Mississippi River Bridge Project  
 Railroad Coordination Meeting  
 March 26, 2008

## Memorandum

To: File  
From: Gwen Lagemann  
Subject: Meeting Minutes  
Date: September 9, 2008

REGARDING: New I-70 Mississippi River Bridge (MRB)  
Crossing  
IDOT Region 5/ District 8  
PTB#/ Item#: 890-160 & 890-161  
**Union Pacific RR Coordination**  
Teng Project No. 20868.001

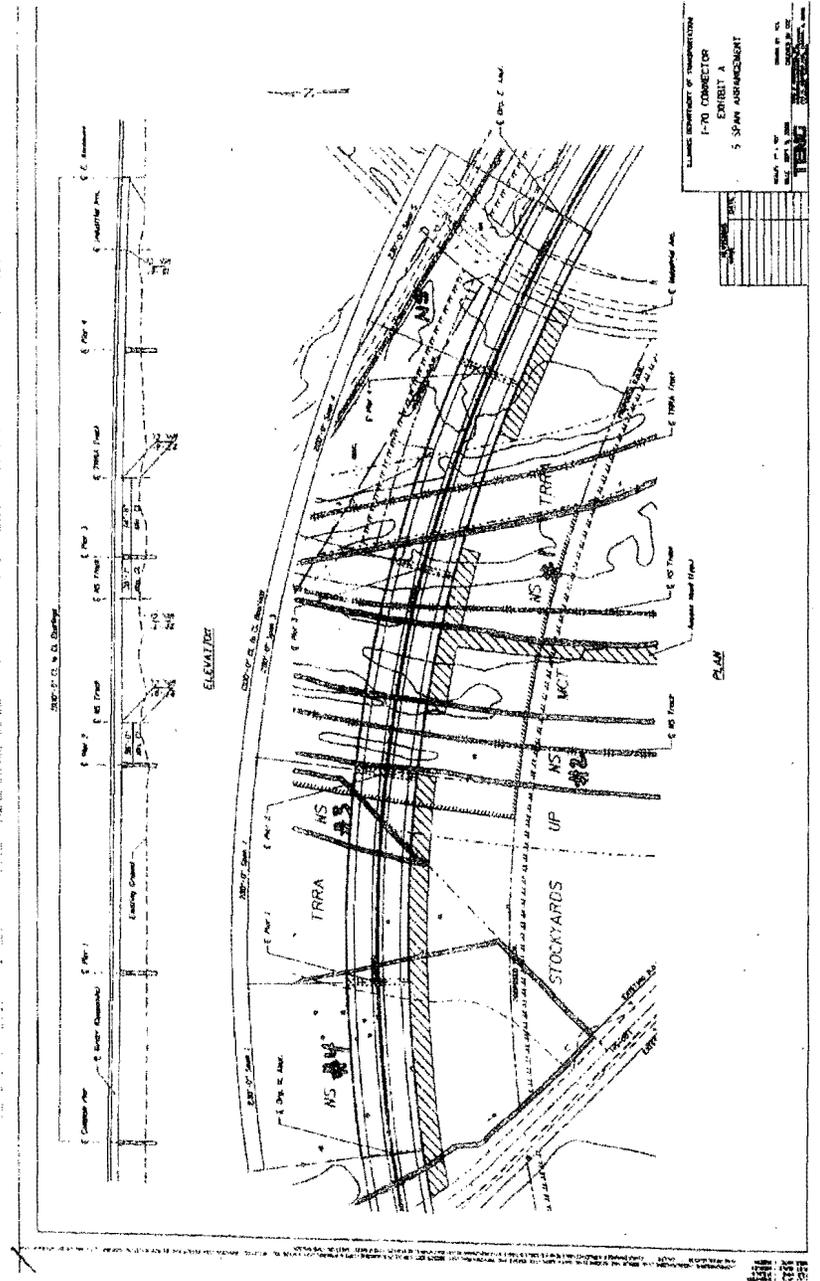
- (2) Teng presented NS with the exhibit which showed a proposed retaining wall along the north side of the I-70 overpass, which will require proposed ROW and temporary easement along the south edge of the NS Darling Spur ROW.

- (a) Teng noted that this existing ROW is 100' wide, however, ~800' to the east of the Industrial Drive at grade crossing, this ROW narrows to 50' and then further narrows to 35' at ~500' further to the east. Teng noted that the 50' and 35' existing ROW widths already constrain the future ability for the Darling Spur to add an additional track within this corridor.

- (b) Teng noted that the existing UP operated single rail operates on the northern 50' width of the existing 100' ROW, and therefore, ROW impact to the south 50' width of the existing 100' ROW may have minimal, if any, effect on current rail operations.

- (4) NS indicated that they had not yet had the opportunity to review the Exhibit with the ROW request at the NS Darling Spur location. NS indicated that they would take the exhibit with them, and further review.

- (a) Teng indicated that Teng would follow up with NS to inquire about this NS Darling Spur ROW. NS Concurred.
- b) Regarding the Right-of-Entry, insurance, and other agreements required by NS, Mr. Kazmierczak requested that R. Stern coordinate directly with him for right-of-entry, railroad protective liability insurance and railroad flagger requirements and costs

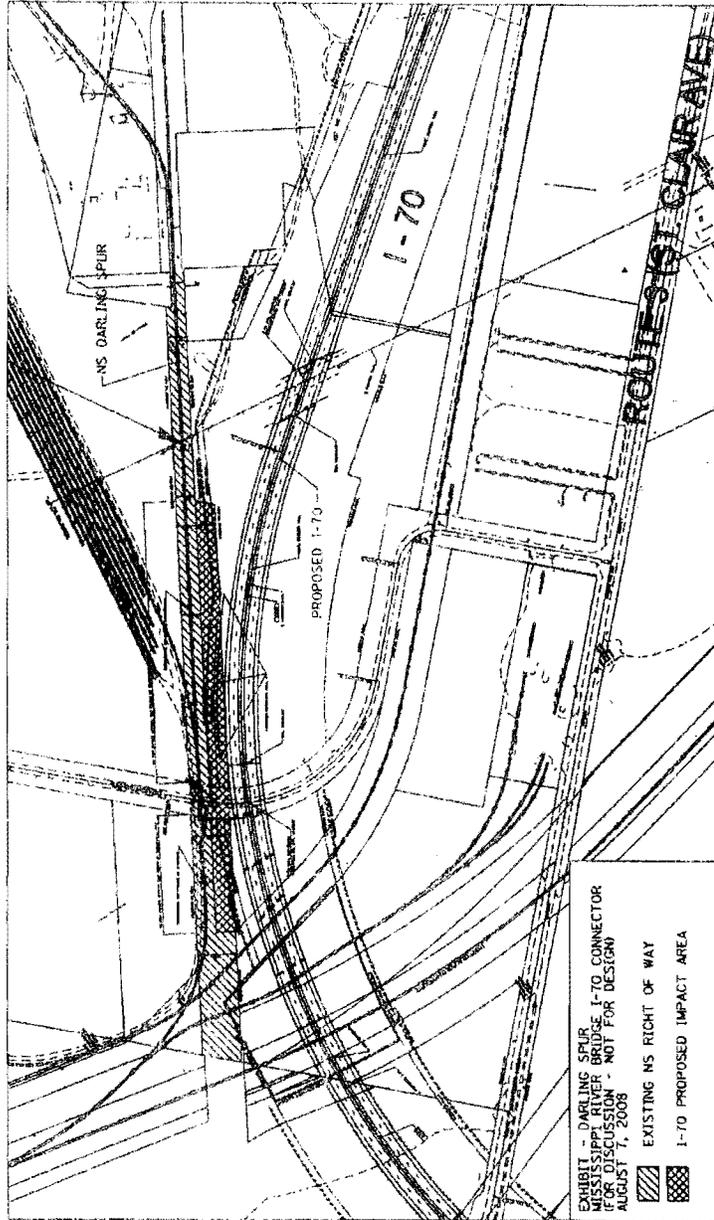
- a) Regarding the 5-span and 7-span options previously forwarded to NS, the NS indicated that the NS approves the 5-span option over the 7-span option.

- (a) NS indicated that they wish to retain the flexibility to add a future second rail, and an access roadway within the NS Packer Spur ROW. Teng noted that the minimum width from the existing NS Packer Spur track to the proposed pier would be 38'-1". NS confirmed that this 38'-1" clearance will be enough to add a future second rail and maintain an access roadway between the future second rail and the proposed pier.

- (b) NS stated that the NS approves the 5-span option.
      - (2) With regard to proposed permanent Access Roads, the access to the proposed pier on the NS Packer Spur ROW will come from the proposed Access Road that will be constructed off of IL 3 and extend north (along the west side of the NS Packer Rail) on MCT ROW. The Access Road will cross the NS Packer Spur near the south end of the proposed NS Packer Spur pier.

- 3) Conclusion:
- a) NS is in support of the 5-span option, and is in agreement with IDOT that the design team will move forward with the 5-span option, including proposal for the permanent Access Roads.

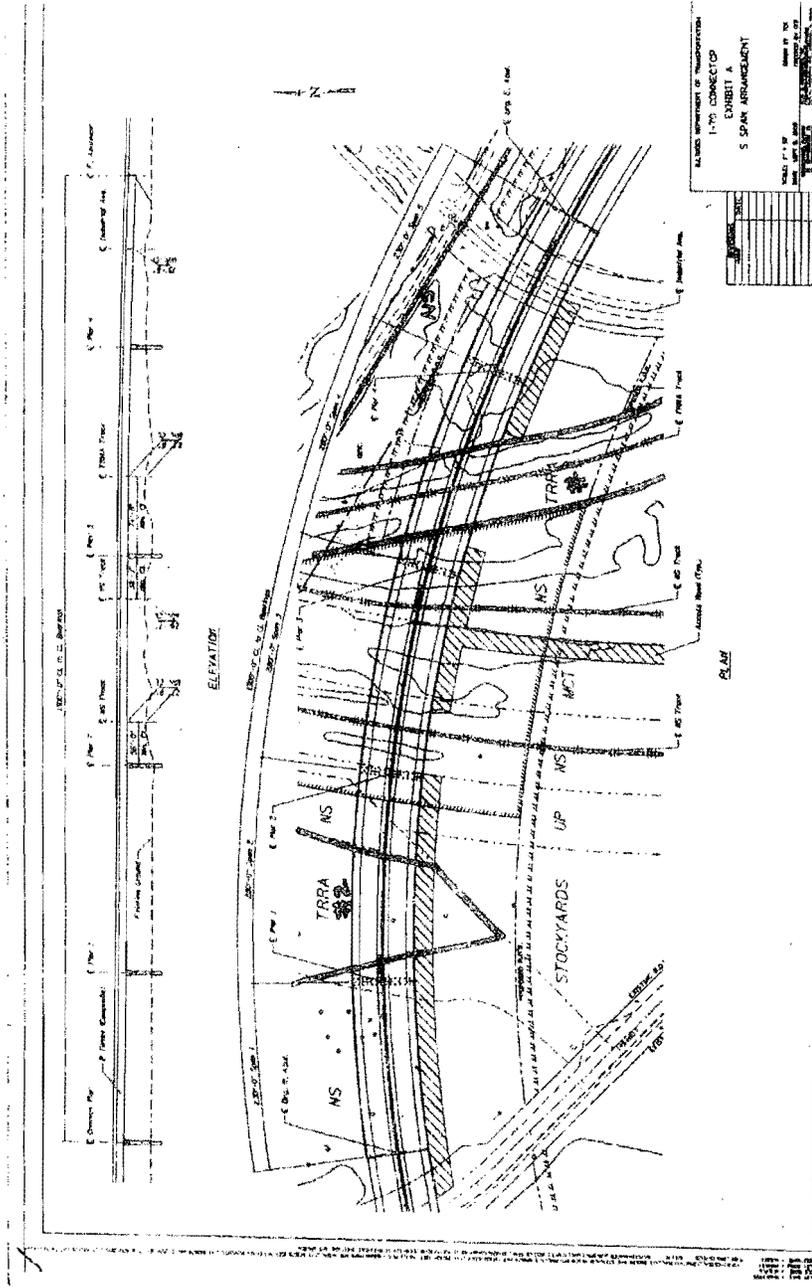
- a) Regarding the 5-span and 7-span options previously forwarded to TRRA, the TRRA indicated that the TRRA approves the 5-span option over the 7-span option.

- i) TRRA Property #1 – TRRA EADS Main
      - (1) With regard to the I-70 structure over TRRA track on the Eads Main, both the 5-span and 7-span options will span over the TRRA 100' width ROW with NO proposed piers located within TRRA 100' width ROW. TRRA stated that the TRRA approves the 5-span option.

- iii) Drainage - TRRA inquired about the proposed drainage for the I-70 structure over the existing rails.
      - (1) TRRA indicated that they do not want drainage from the I-70 overpass to outlet onto the TRRA track.

- a) TRRA is in support of the 5-span option, and is in agreement with IDOT that the design team will move forward with the 5-span option, including the proposal for permanent Access Roads.
- b) Teng will coordinate with TRRA to finalize appropriate ROE and insurance requirements.
- c) TRRA will forward recent survey information for the area to the District.
